UNITED STATES ENVIRONMENTAL PROTECTION AGENCY
REGION IX
75 Hawthorne Street
San Francisco, CA

March 26, 2018

Thank you for providing for review the *Draft Work Plan, Radiological Survey and Sampling,* Former Hunters Point Naval Shipyard, San Francisco, California ("Work Plan"), February 2018. The U.S. Environmental Protection Agency (EPA) reviewed this report in detail with a technical team including national experts in health physics, geology, and statistics.

EPA Review of the Draft Work Plan Radiological Survey and Sampling
Former Hunters Point Naval Shipyard,
San Francisco, California, February 2018

Figure 1. Distribution of Ra-226 Off-Site Laboratory Measurements in picocuries per gram (pCi/g) in Background Reference Areas

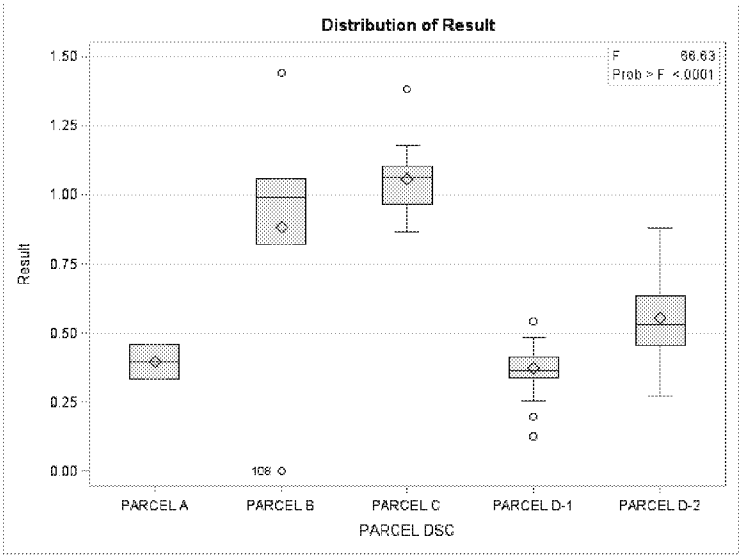
Reviewer Comments: In order to meet MARSSIM and NRC criteria, sample sizes for background reference areas should be computed per independent interval, surface soils and subsurface soils, not across both. Additionally, it is clear from historical data provided by the Navy and collected at the background reference areas in Parcels A, B, C, D-1, and D-2, that variability is not consistent across the five areas for off-site laboratory Ra-226 measurements (Figure 1).

Recommendations: Given the differences in variability and mean/median concentrations for Ra-226 as demonstrated in Figure 1, it is recommended that background reference area sample data should not be combined across the five areas, but rather background reference areas should be established per Parcel with sample sizes computed based on the variability within each background reference area per independent interval (surface soils and subsurface soils).

Sample sizes should be justified with detailed statistical analyses and explanations of how inputs to the computations were derived, including specifics of how estimates of variability were obtained (e.g., what data was included in the calculation, how and where the data was collected, what assumptions were made). If measurements from multiple background reference areas will be combined, the results of a comparative analysis such as an Analysis of Variance (ANOVA) or non-parametric equivalent (Kruskal-Wallis Test) must be documented to support combining the areas. These comparative tests will establish if there is a statistically significant difference between Ra-226 and Cs-137 in the background reference areas at a specified confidence-level.
